**Re: Christina Lake Thermal Project Phase H and Eastern Expansion
Project Update and Supplemental Information Request 2 Responses
AER Application No. 1758947
EPEA Application No. 019-48522**

The purpose of this document is to provide responses to the Round 2 SIR package and provide updated information regarding the Project (Project Update). This document is organized into two parts as follows:

FIGURE: 2

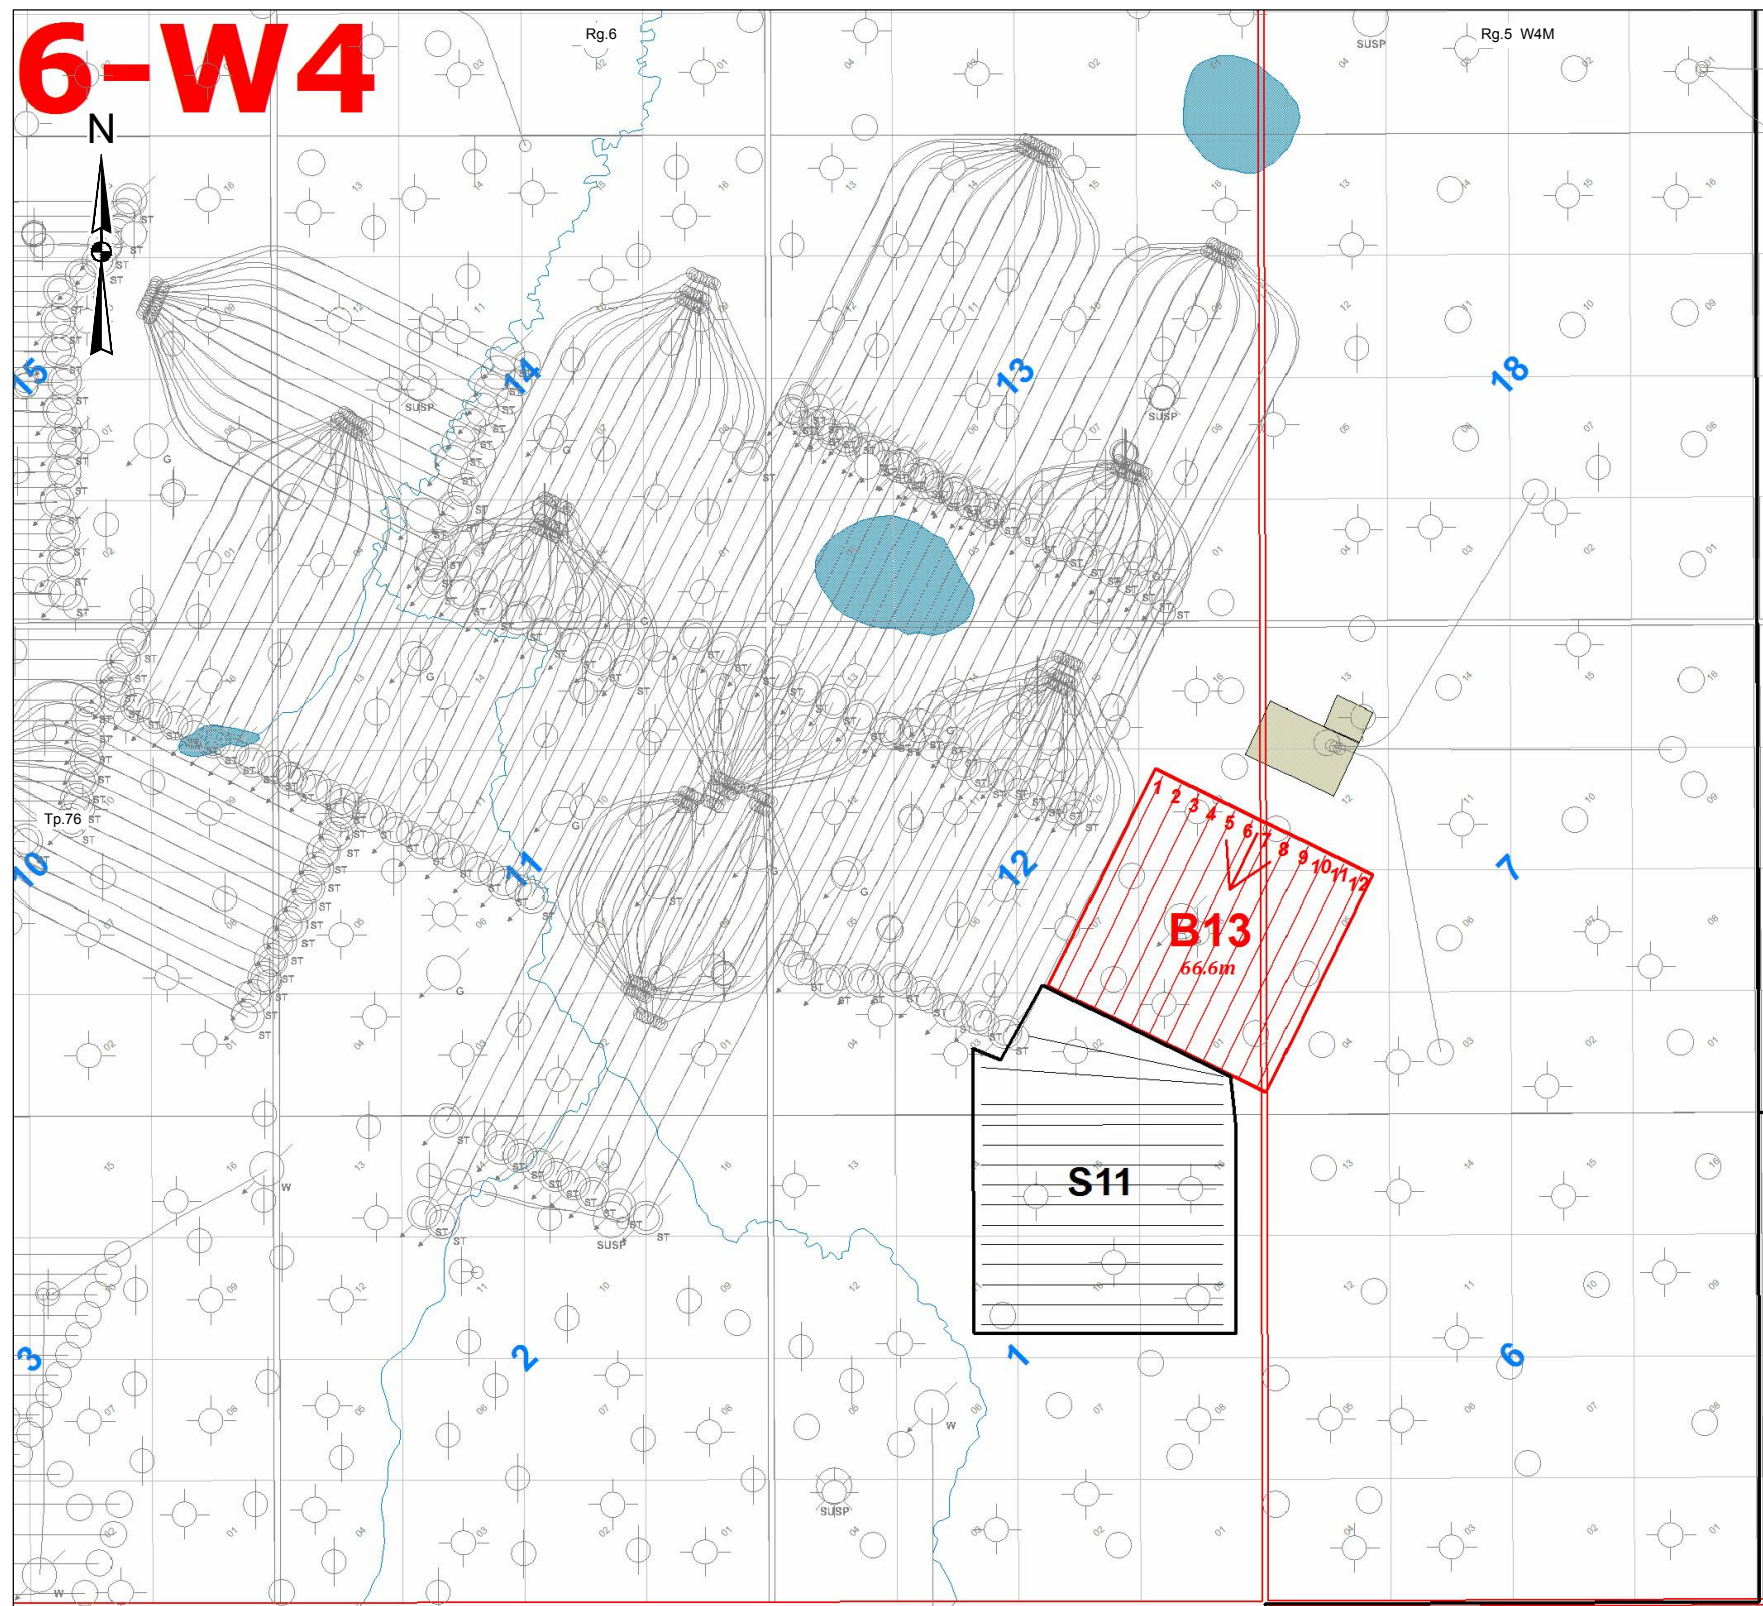
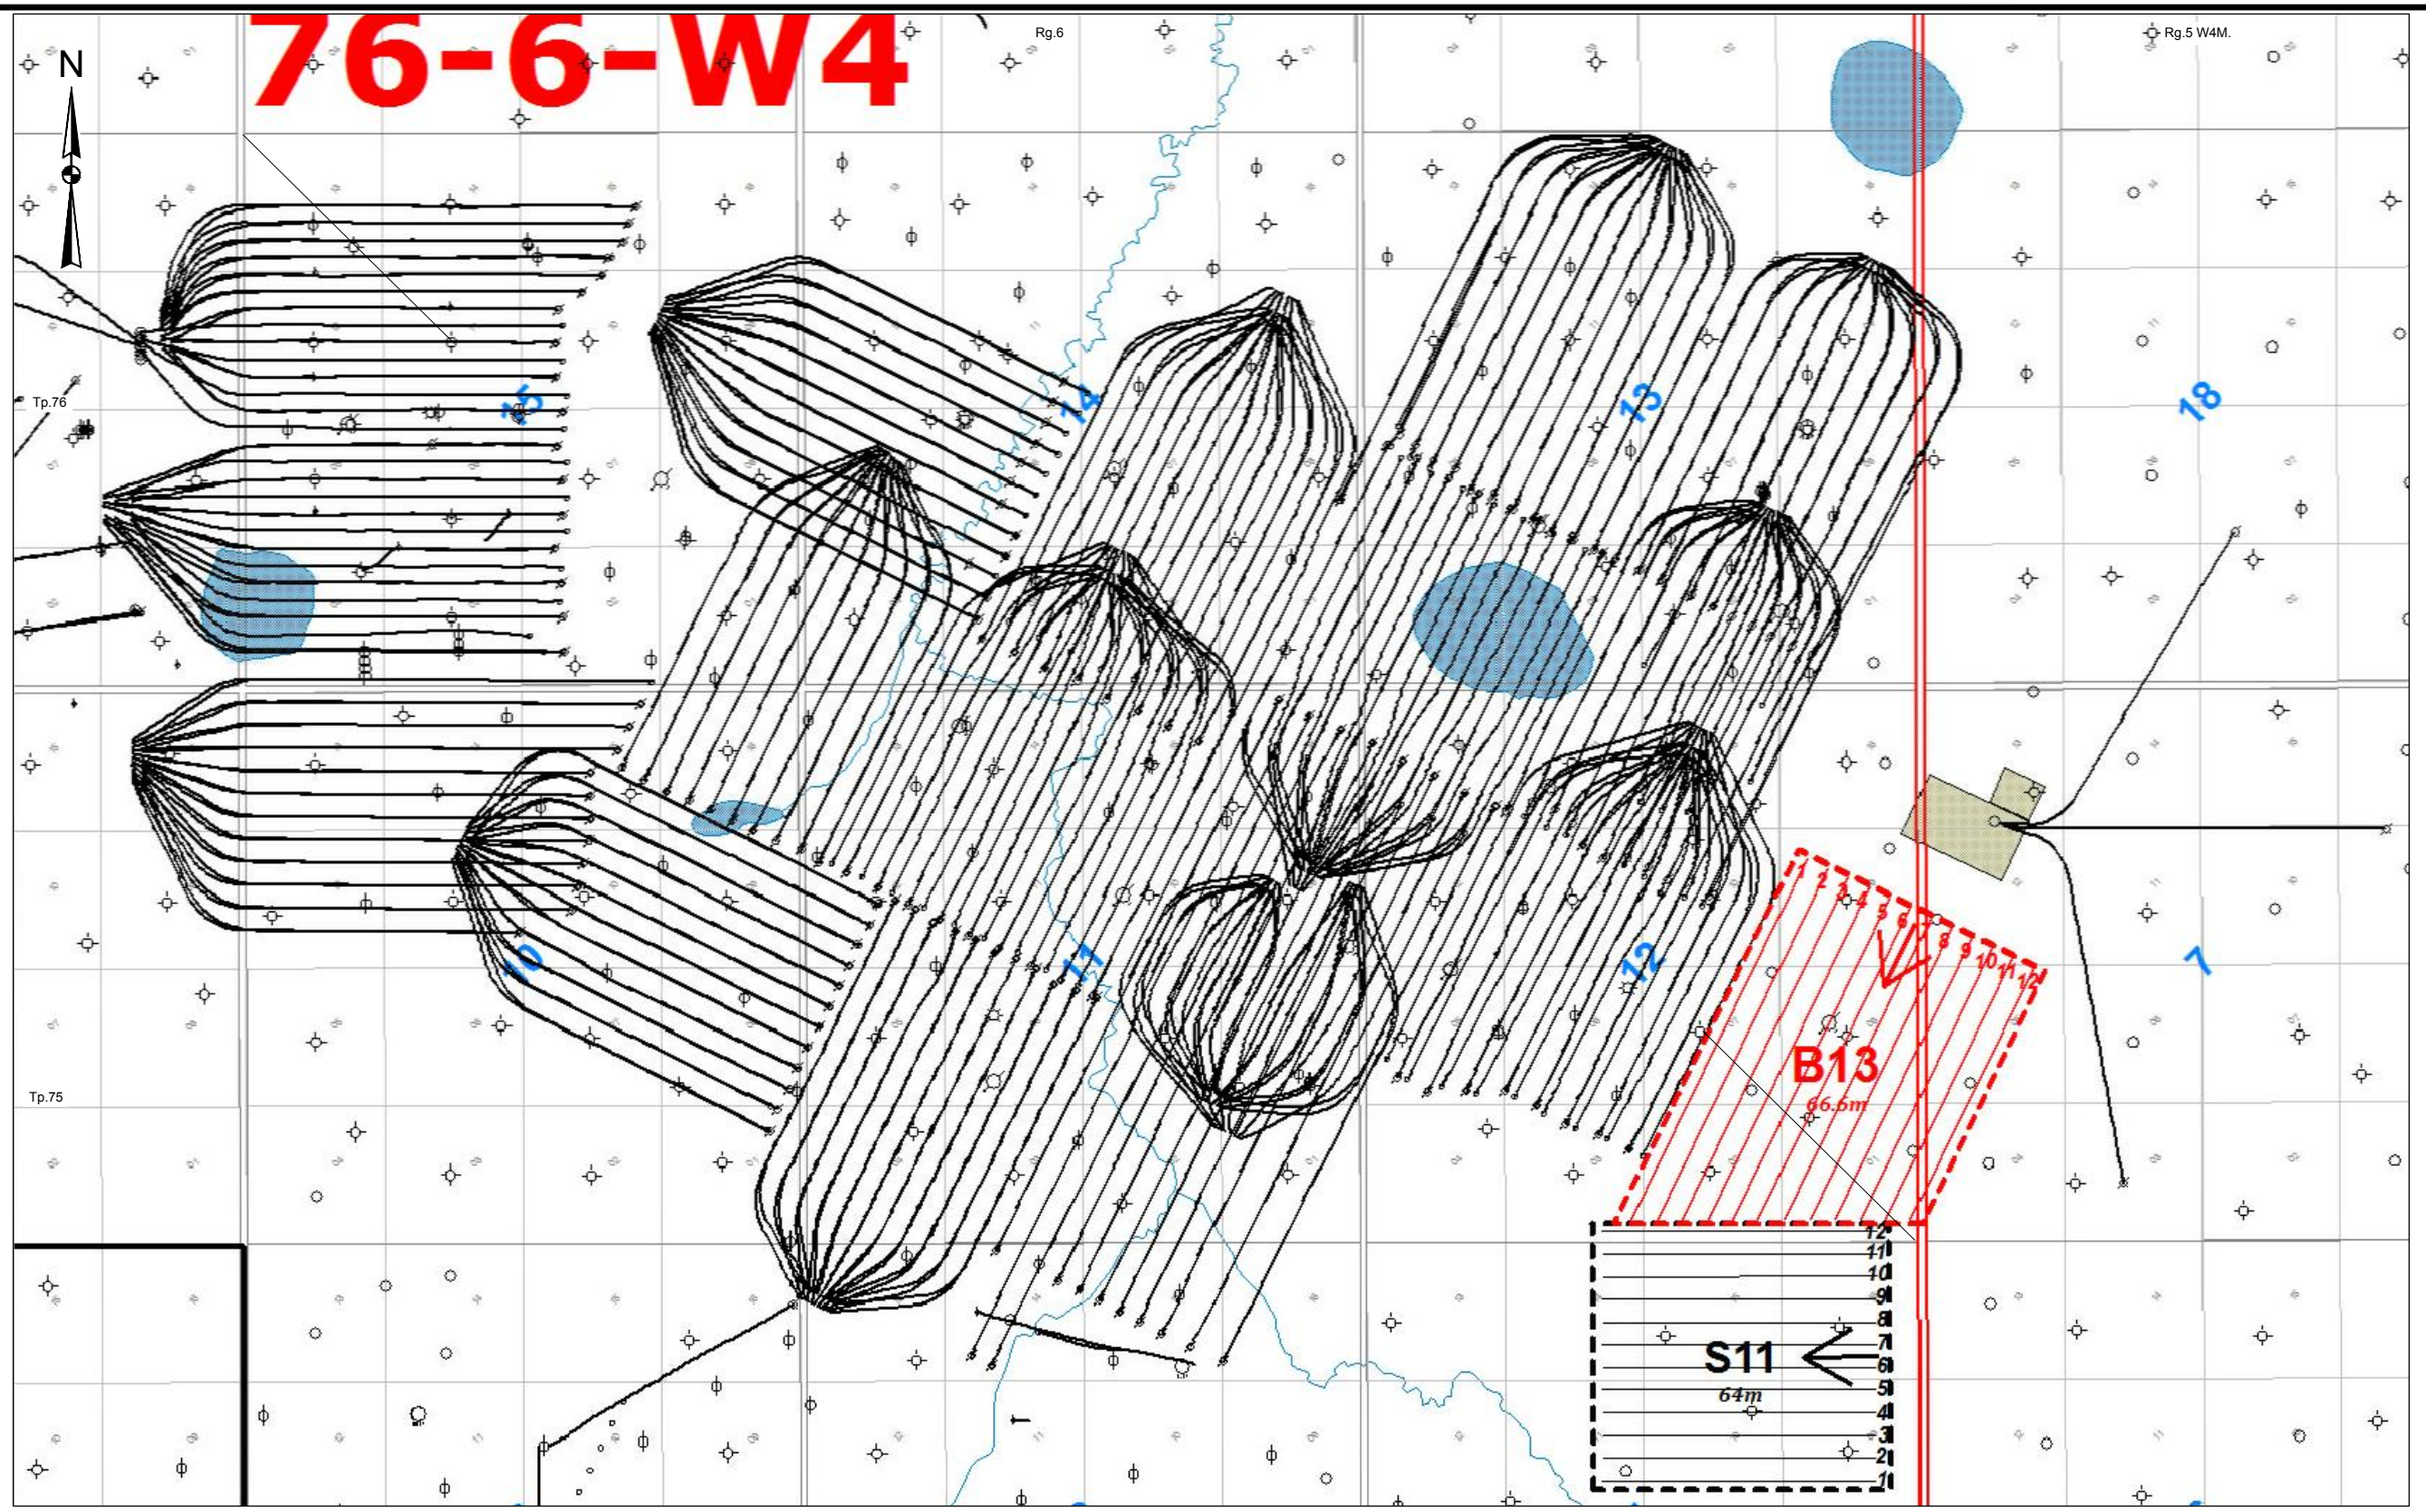
Due to this proposed amendment, an update to the Project S11 well pad well drainage pattern is also required. The proposed change will not impact any of the other well pad drainage patterns given in the Project Application. Given the planned amendment for the B13 well pad, the following changes are proposed for the S11 well pad subsurface drainage pattern:

- the northern portion of the S11 drainage box has been revised to accommodate the extended length of the B13 well pad well pairs; and
- the two northern S11 well pairs have been removed and the total well pair count for the pad has been reduced to twelve well pairs.

The updated well count and well lengths for the S11 well pairs are provided in [Table 1](#). The inter well spacing for the twelve proposed well pairs remains unchanged at 64 m. [Figure 1](#) shows the current applied for Project S11 and B13 well pair patterns, whereas [Figure 2](#) gives the proposed updated well pair patterns for the B13 and S11 pads.

FIGURE: 2-1

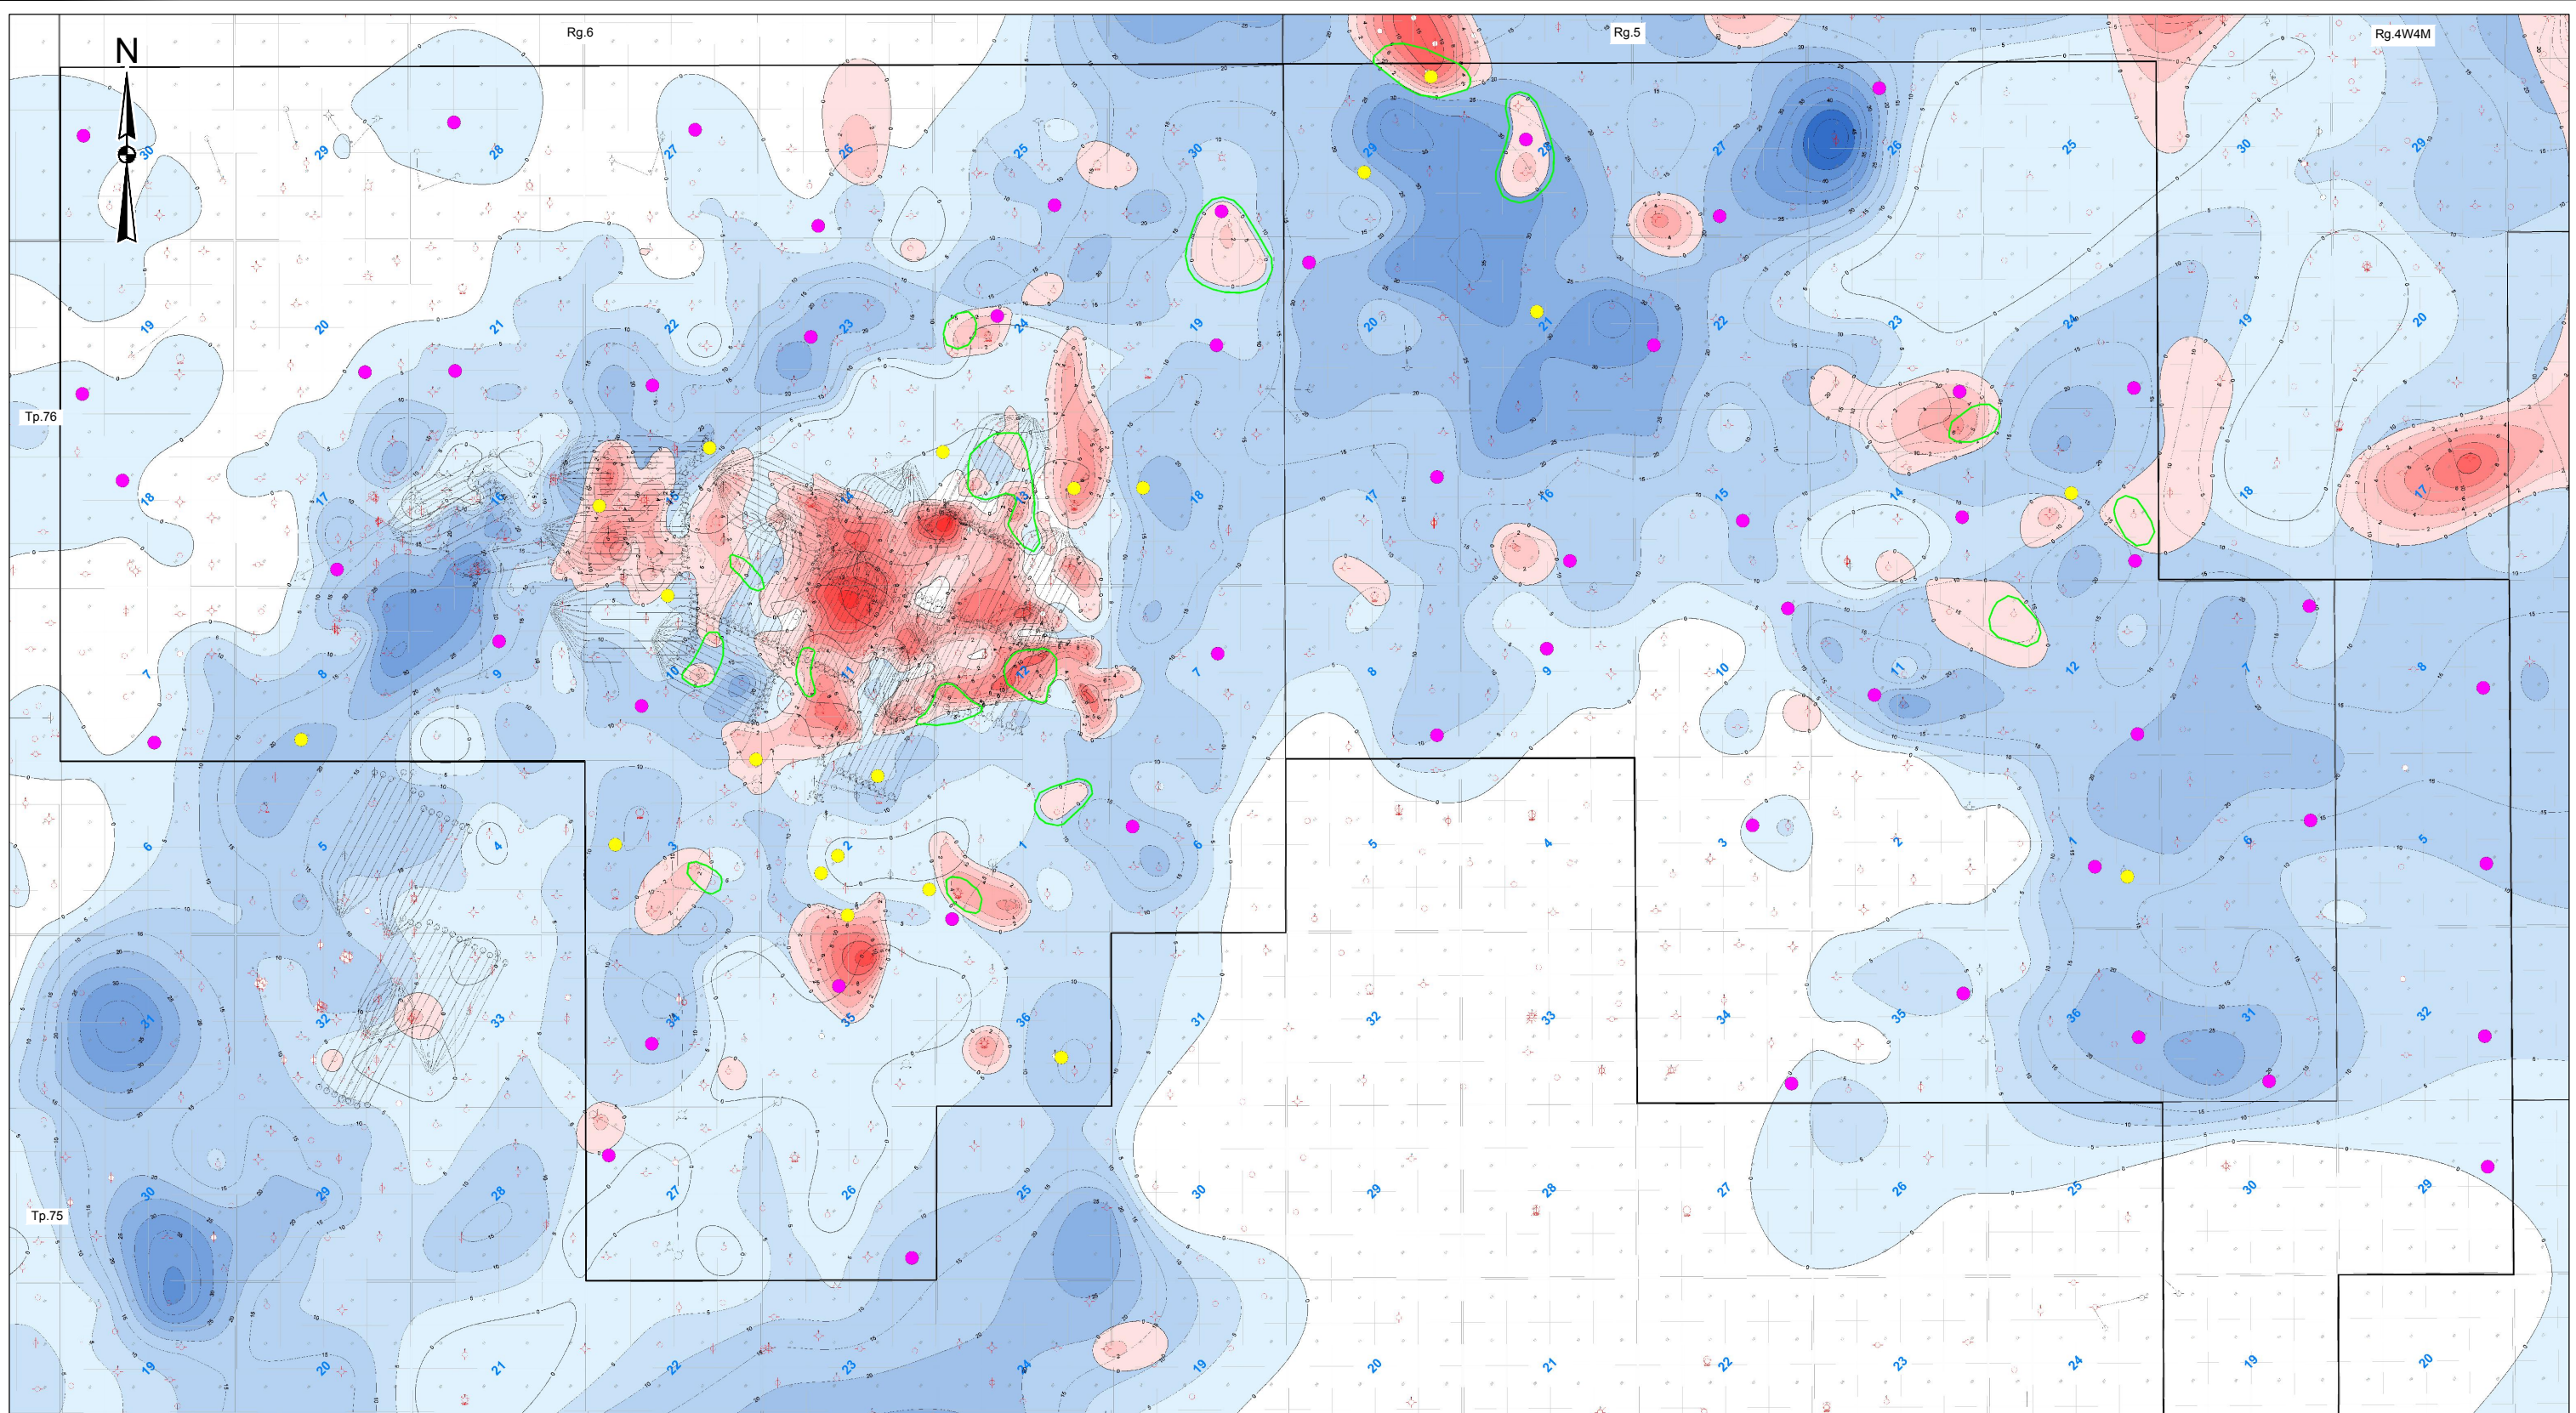
- 2. SIR 1, Response 15: Figure 15-1, Page 36. This figure does not include a note in the legend for the existing and planned bottom water or top gas monitoring wells. A note in the legend for the green polygons was not included either. Update Figure 15-1 to include a complete legend.**

The AER Round 1 SIR 15, Figure 15-1 with the legend included is provided as updated [Figure 2-1](#).
